ADDITIONAL DESIGN INFORMATION
1 DENISON STREET

We write to you in relation to 1 Denison Street, North Sydney and in particular in relation to Modification 5 which we have lodged in relation to MP08_0238. Specifically you have asked for further clarification in relation to the proposed relocation of the bridge linking the site with Tower Square and the proposed retail reconfiguration.

Figure 1 – Approved retail design north of the new link road
Source – HDR Rice Daubney

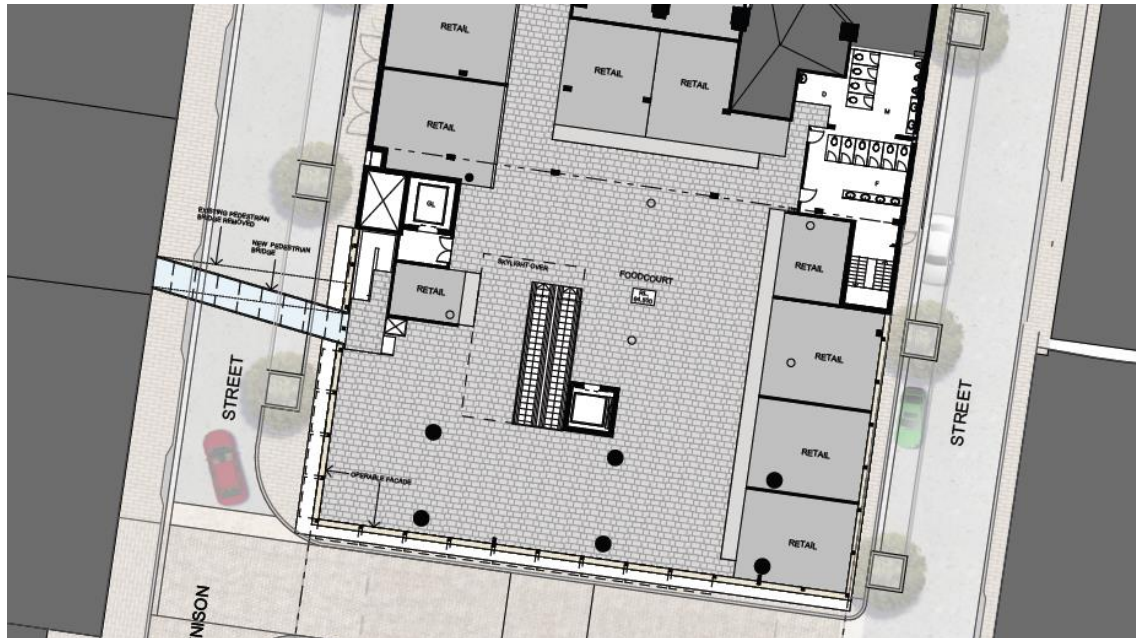
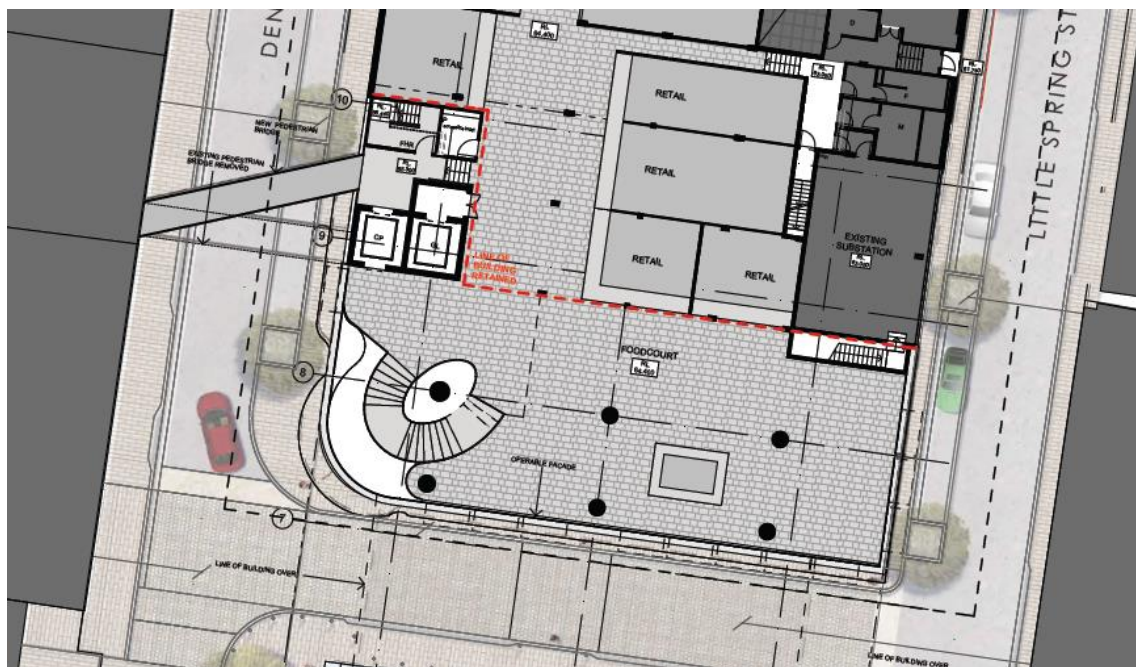
As can be seen in **Figures 1 and 2** one of the key changes proposed is the introduction of a new spiral staircase in the south eastern corner of the retail space in the northern part of the podium and the removal of the escalators which were originally proposed in the centre of the food court. This design change has been proposed to create a design feature which contributes positively to the appearance of the proposed built form and also to better identify and connect the food court area with Denison Street. The removal of the escalators will also positively contribute towards the amenity of the food court area for patrons which has now been reduced in size as a result of the retention of the electricity substation. Equitable access will still be available via the lifts which are proposed to service the ground and retail/food court levels and northern portion of the podium together with the bridge level.

As a result of this design change it has been necessary to relocate where the Tower Square bridge connects with the approved building. It is now proposed to connect further north of the alignment of the existing bridge. The design and width of the bridge will remain the same as that originally approved, only the alignment is proposed to change. The bridge will provide greater access than that currently available through the integration of a lift for wheelchair users..

It is noted that the toilets within the approved food court have been deleted from the scheme, this is because the existing toilets are to be retained and refurbished.
